TENNESSEE VALLEY AUTHORITY

In accordance with 10 CFR Parts 50.59 and 50.90, we are enclosing 40 copies of a temporary change which involves installation of five sewage treatment facility lines across, and eight feet above, the essential raw cooling water (ERCW) supply headers. Tests performed by TVA indicate that 10 feet of Type B backfill is sufficient as a tornado missile barrier.

UNREVIEWED SAFETY QUESTION ON NEW SEWAGE TREATMENT FACILITY AT SEQUOYAH NUCLEAR PLANT

NEW SEWAGE TREATMENT FACILITY PIPING

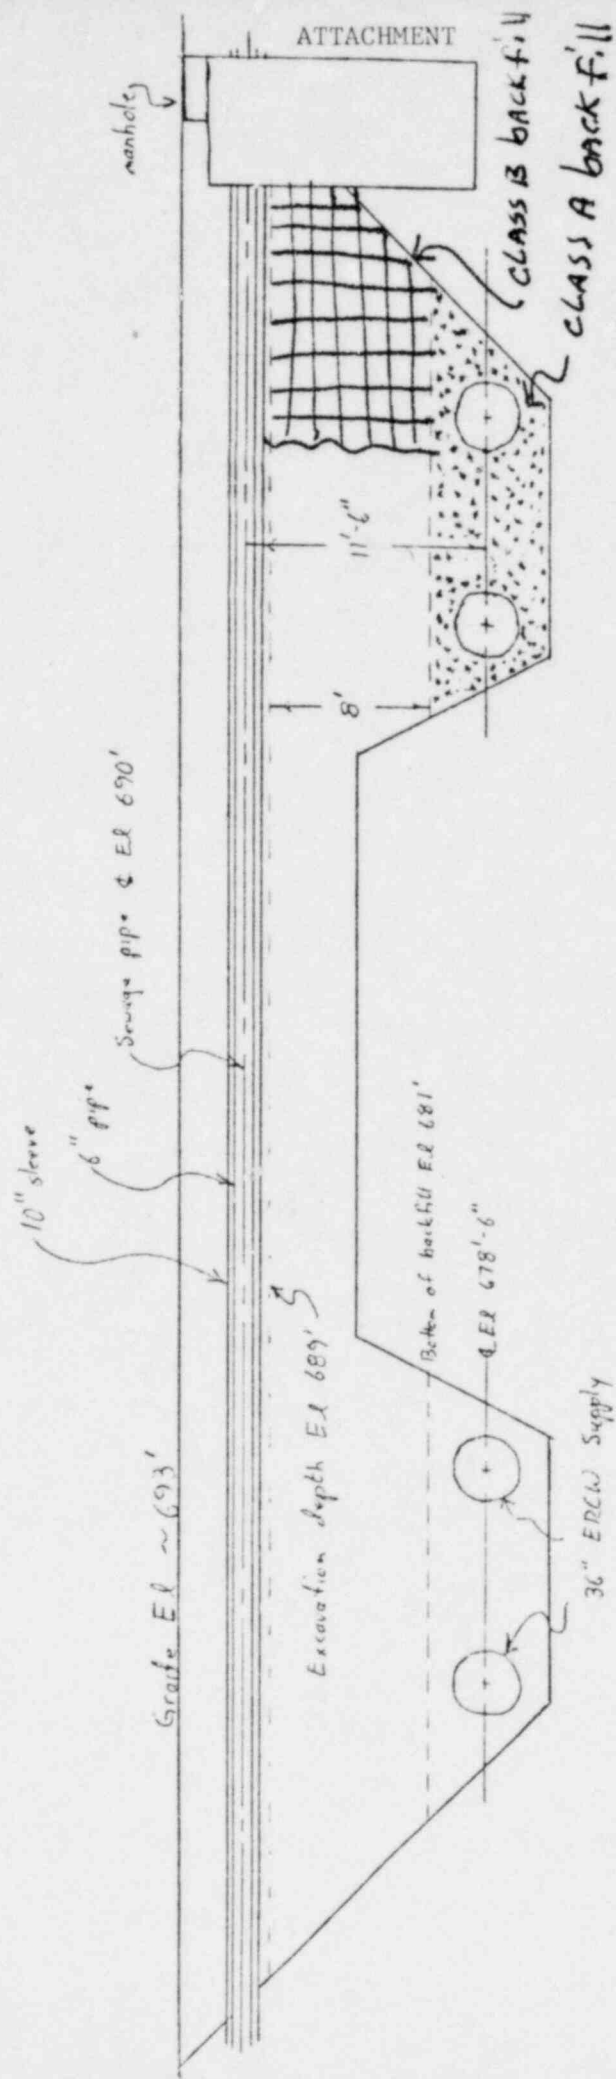
TVA has designed a new sewage treatment facility for Sequoyah to meet increased sewage needs. The facility includes one 3-inch and four 6-inch lines which are to be laid 11.5 feet above the four 36-inch essential raw cooling water (ERCW) supply headers (centerline-to-centerline distance, see attached figure). This will necessitate excavation of a portion of the backfill which serves as a tornado missile barrier above the headers. Tests performed in the past by TVA indicated that 10 feet of this backfill are sufficient to protect the pipes from tornado missiles. However, while the five sewer lines are being laid, only eight feet of Type B backfill will be in place (see attached figure). Therefore, it has been determined that installation of this segment of piping constitutes an unreviewed safety question thus requiring NRC concurrence.

Therefore, we are requesting NRC approval of the installation plan based on the fact that the probability of missile damage to the ERCW piping during the excavation period is extremely small. This probability is given by the following:

$P_{d/t}$ = probability that, given a tornado at the site, a missile is hurled downward toward the small excavation area with sufficient velocity to penetrate the eight feet of backfill and damage a header. This value is not precisely known but is obviously much less than 1.

$$\text{Hence, } P = (4.5 \times 10^{-5} \text{ y}^{-1}) \left(\frac{5 \text{ y}}{365} \right) (P_{d/t})$$

$$P = 6.0 \times 10^{-7} P_{d/t}$$

$$P \ll 6.0 \times 10^{-7}$$

Therefore, the installation of the new sewage treatment facility lines will necessitate excavation of a portion of the backfill which serves as a tornado missile barrier above the headers. TVA has determined that installation of this segment of piping constitutes an unreviewed safety question requiring NRC concurrence. Since the probability of missile damage to the ERCW piping during this period is $<6.0 \times 10^{-7}$, we are requesting a maximum of five days total time for excavation, installation of piping, and backfilling.
